Proposed Frontier and Wind Garden Energy Facilities,  
Makana Municipality, Eastern Cape

## **Review of Visual Impact Assessments**

20 April 2021

Prepared by  
Bernard Oberholzer and Quinton Lawson

map 3 : Fronteer WEF DEFF Screening Tool

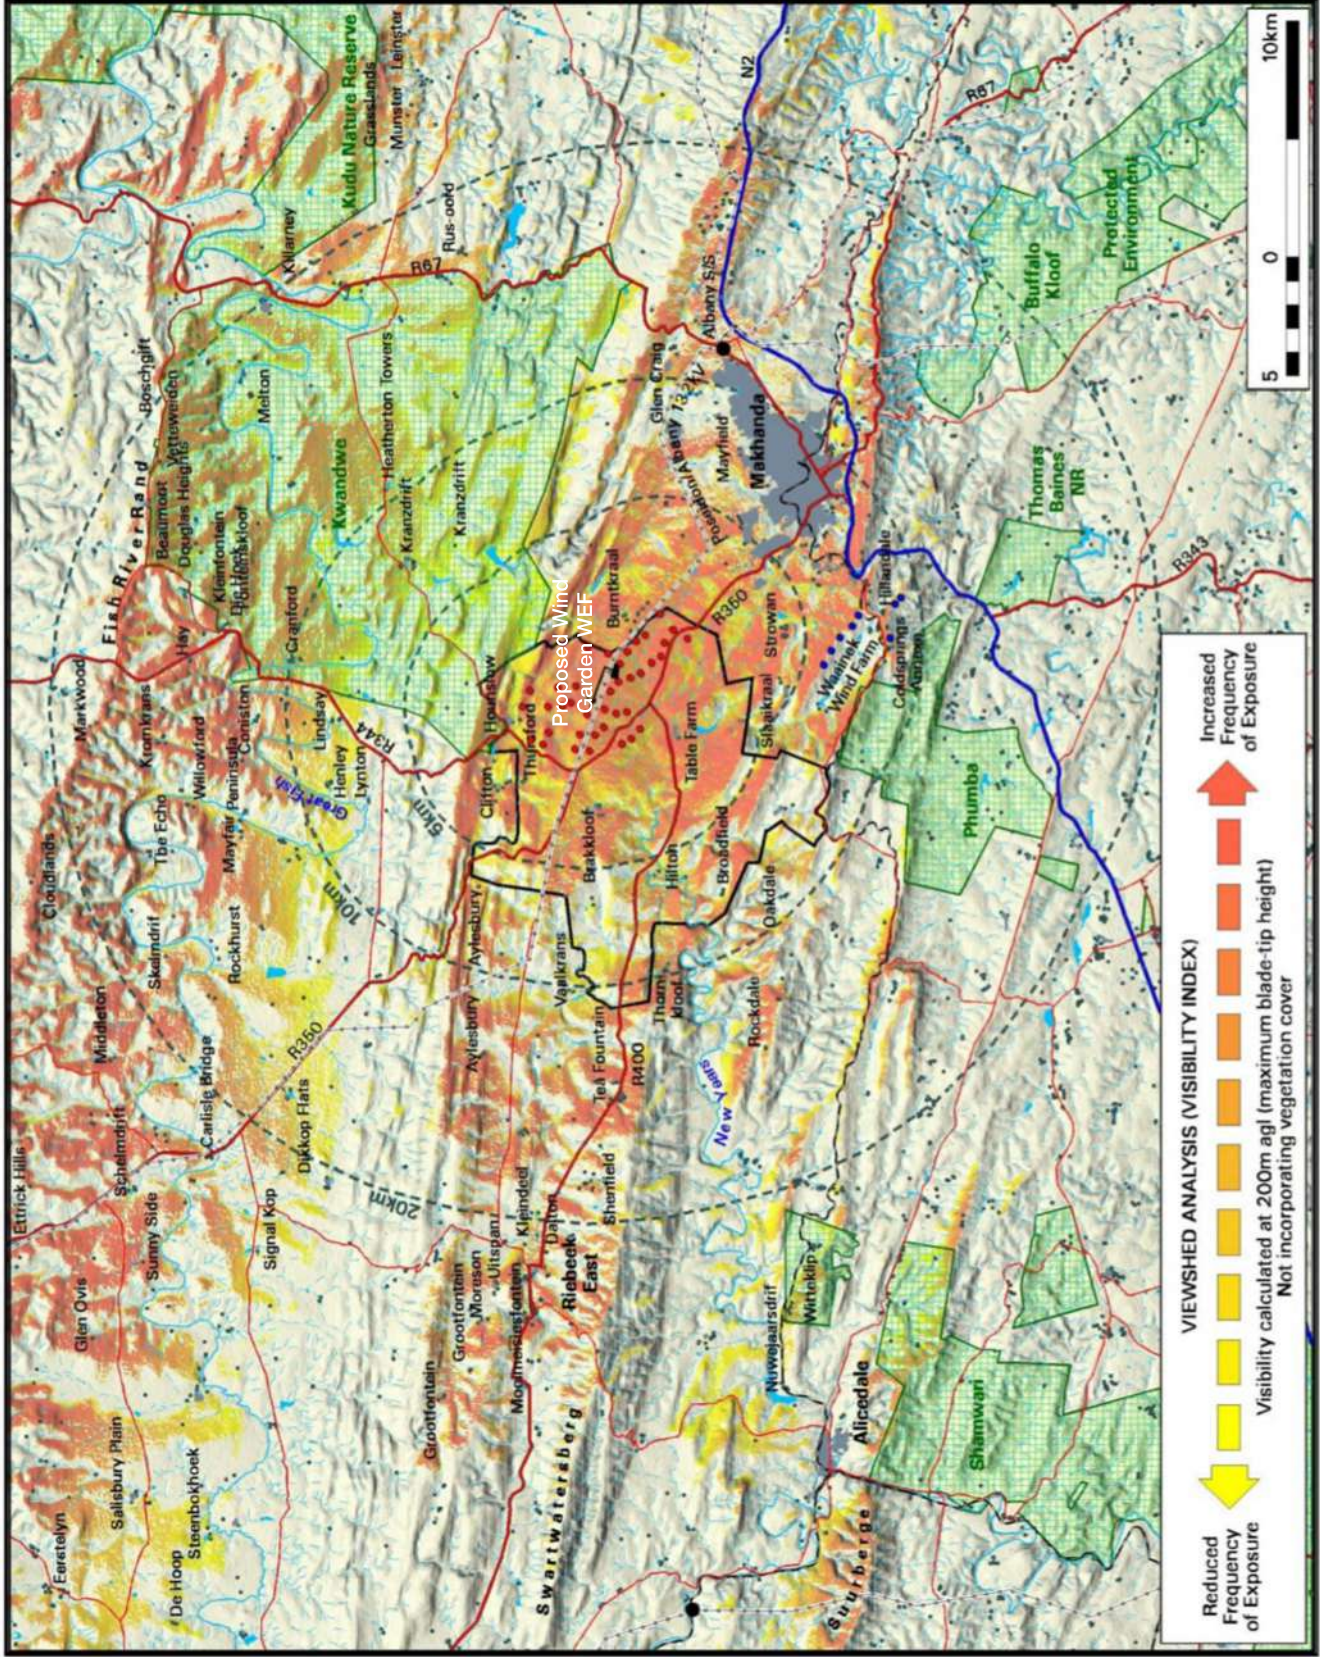
In terms of Government Notice No. 648, dated 10 May 2019, there is a requirement that Initial Site Sensitivity Verification Reports be produced for a development footprint. The purpose of the Site Verification is that the VIA report confirms or disputes the current use of the land and environmental sensitivity as identified by the national web based environmental screening tool. The current VIA Reports fail to include a 'Site Sensitivity Verification Report'.

For ease of reference, the Landscape Theme (visual and scenic resources) for the Cookhouse REDZ is attached (Map3) for both the Fronteer and Wind Garden sites. The maps indicate that a number of the proposed wind turbines would occur in a 'very high' sensitivity zone. The VIA Report is then required to confirm or dispute the DEFF screening map.

map 14 : Fronteer WEF • Visual Sensitivity : Airfields 3km, Makhanda Airport 8km

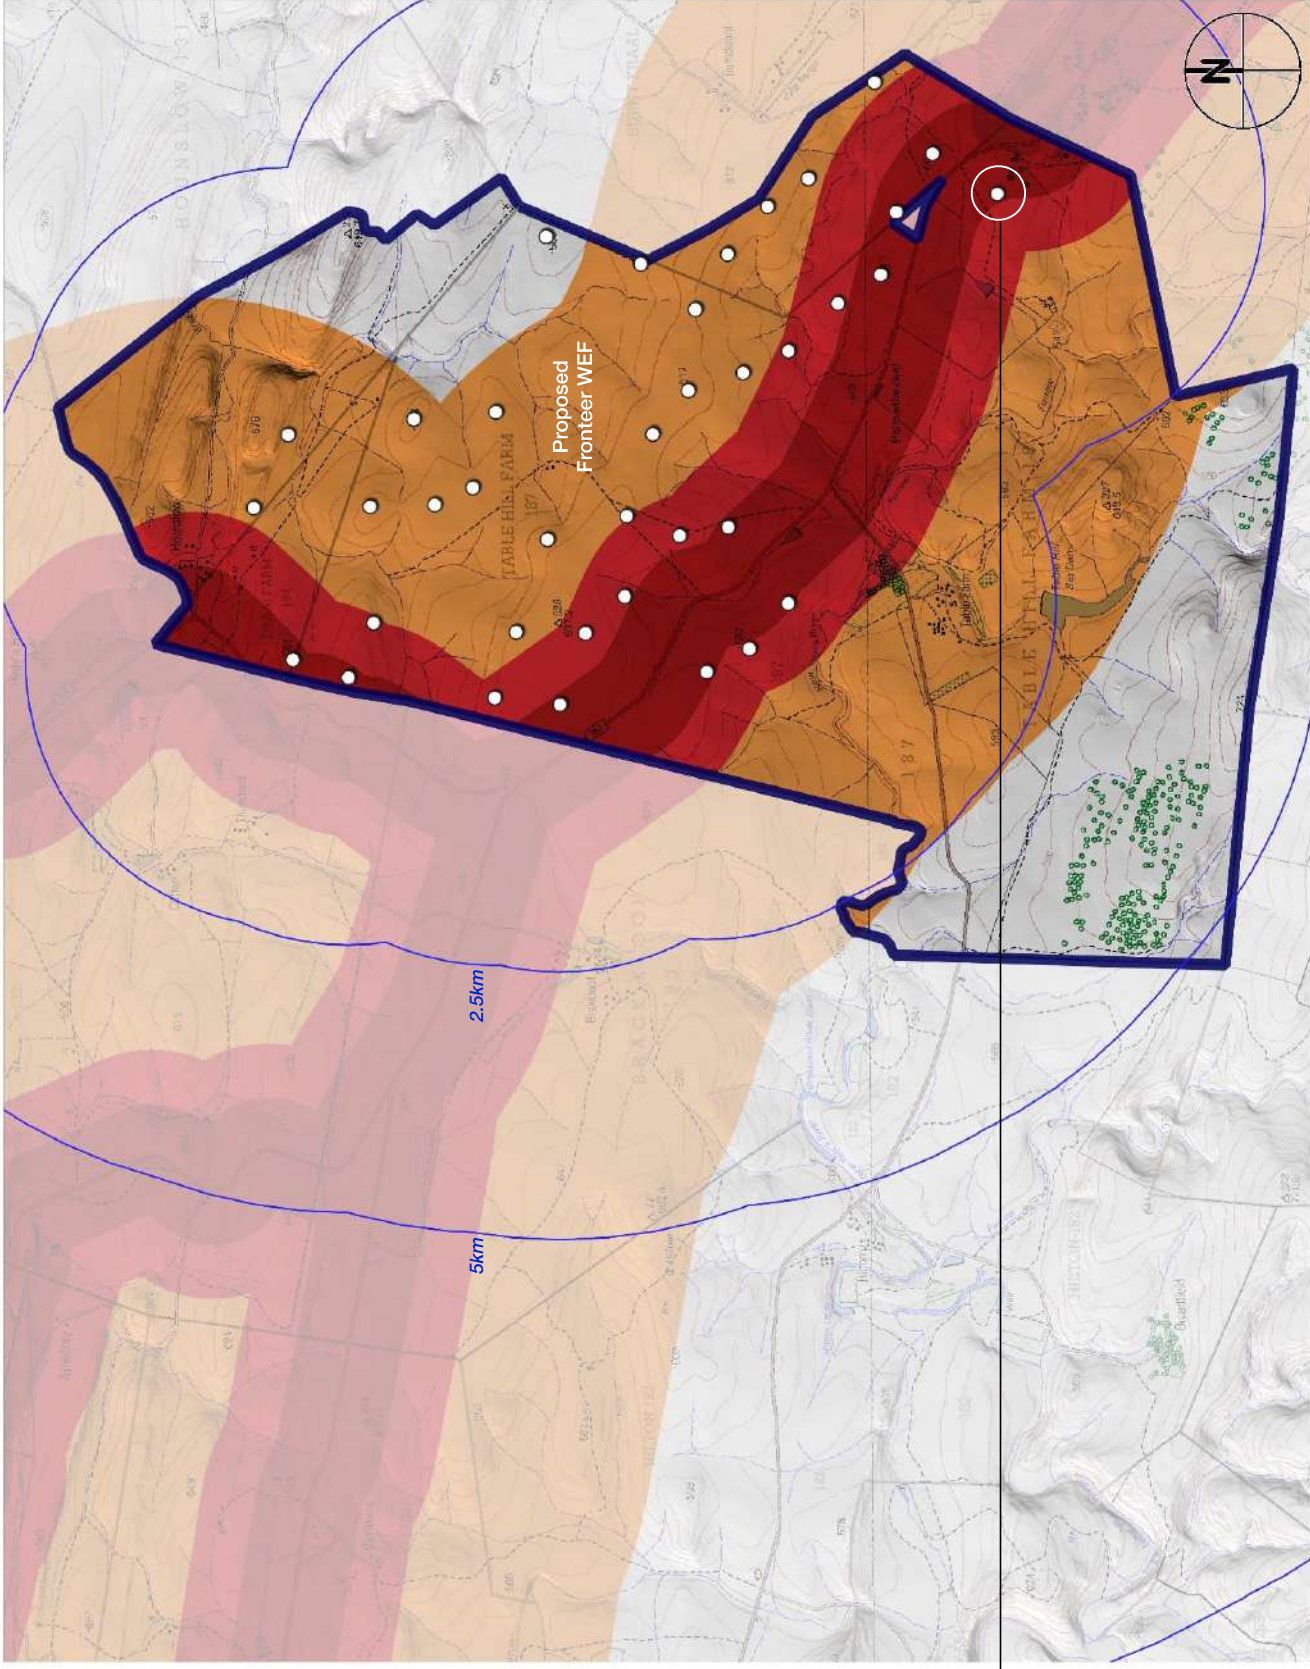
According to Regulations from The Civil Aviation Act (Act 13 of 2009), obstacle limitations need to be taken into account near airports, such as the Makhanda (Grahamstown) airport. These include the following regulation:

*No buildings or objects higher than 45 meters above the mean level of the landing area, or, in the case of a water aerodrome or heliport, the normal level of the water, must without the approval of the Director be erected within a distance of 8 kilometer measured from the nearest point on the boundary of an aerodrome or heliport.*

The 8km buffer is indicated on the attached Map 14, indicating that the siting of about half of the wind turbines in the proposed Fronteer Wind Farm could be affected.

map 17 : Fronteer WEF • Visual Sensitivity : Composite NoGo Areas

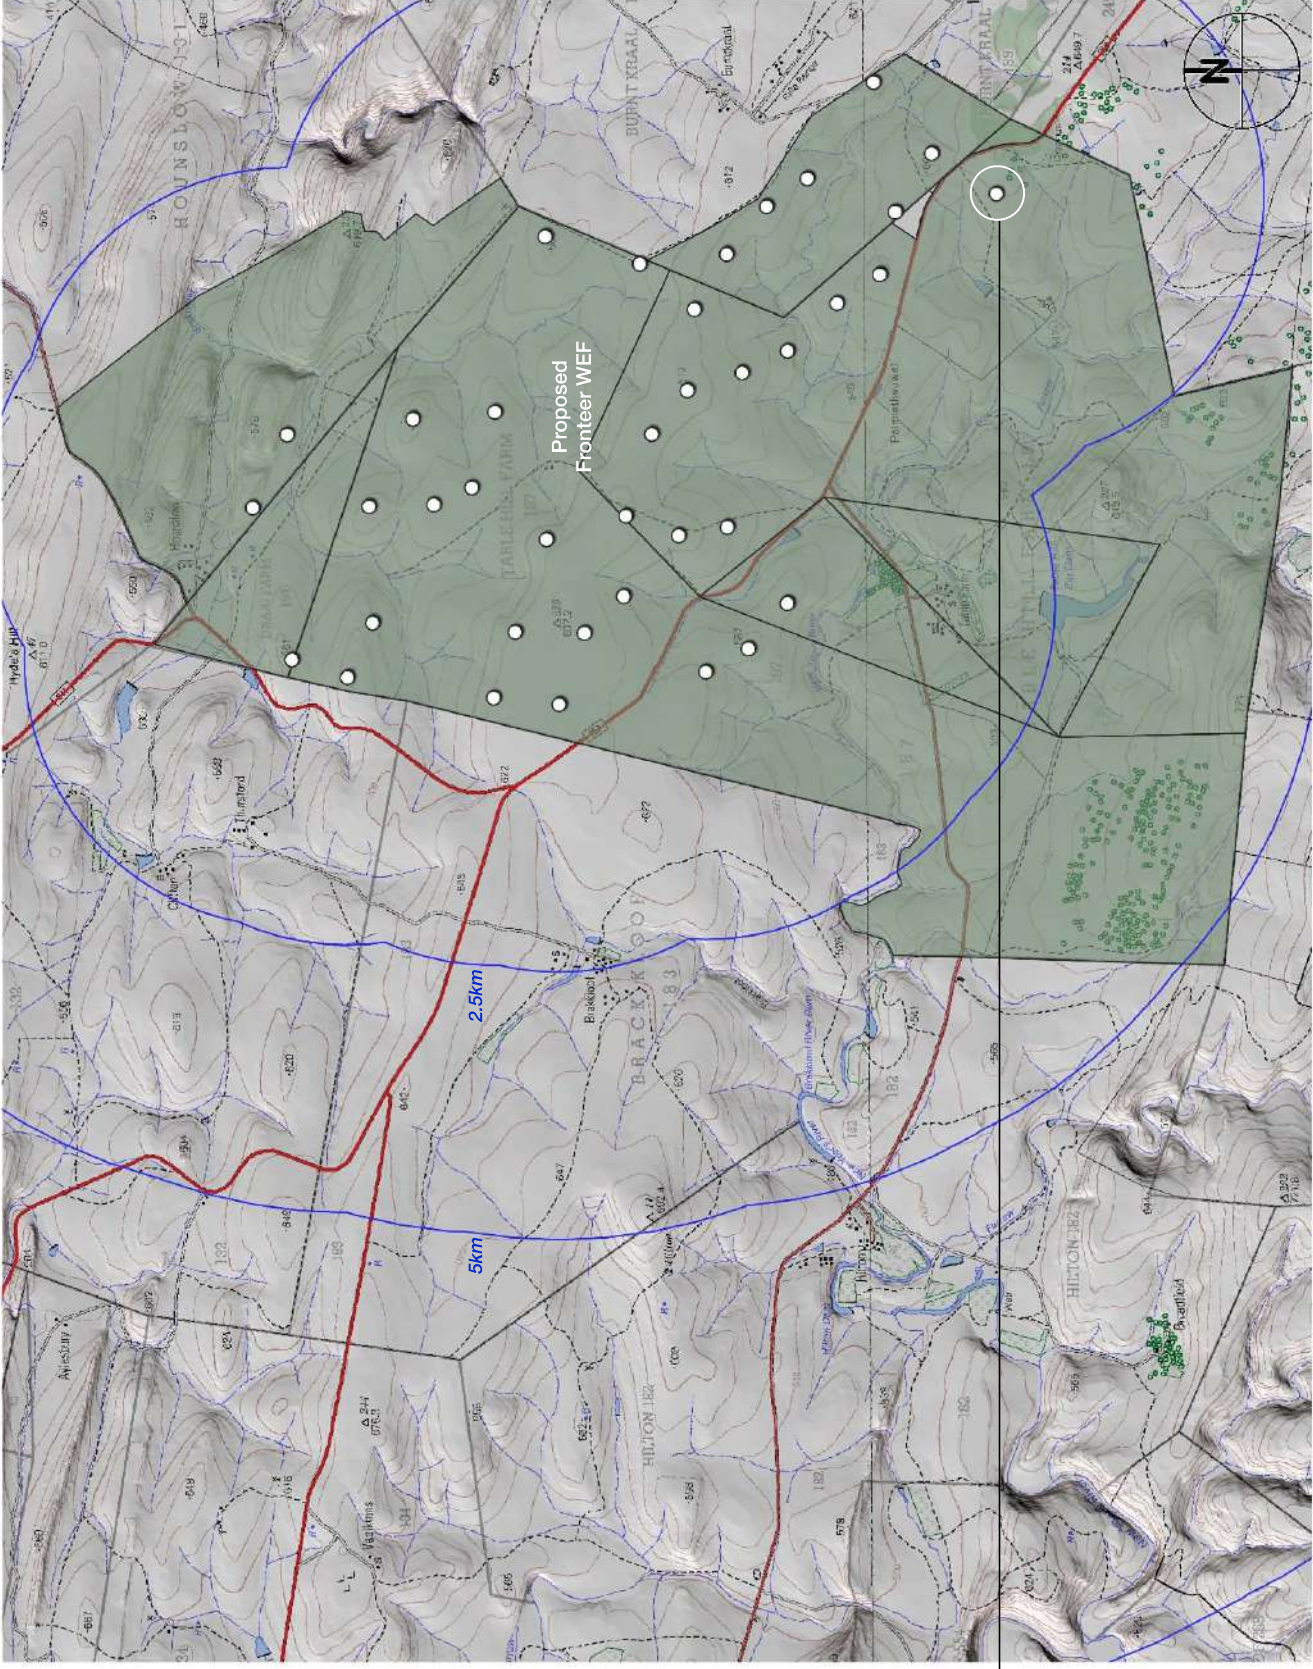
Given the above considerations, it was found during this Review that a large number of the proposed wind turbines could potentially represent a fatal flaw according to the visual sensitivity maps attached to the Review.

Based on the desktop mapping prepared by the Reviewers, it appears that about half of the proposed Fronteer wind turbines are potentially located in no-go areas, and similarly, about a third of the proposed Wind Garden turbines are in no-go areas.
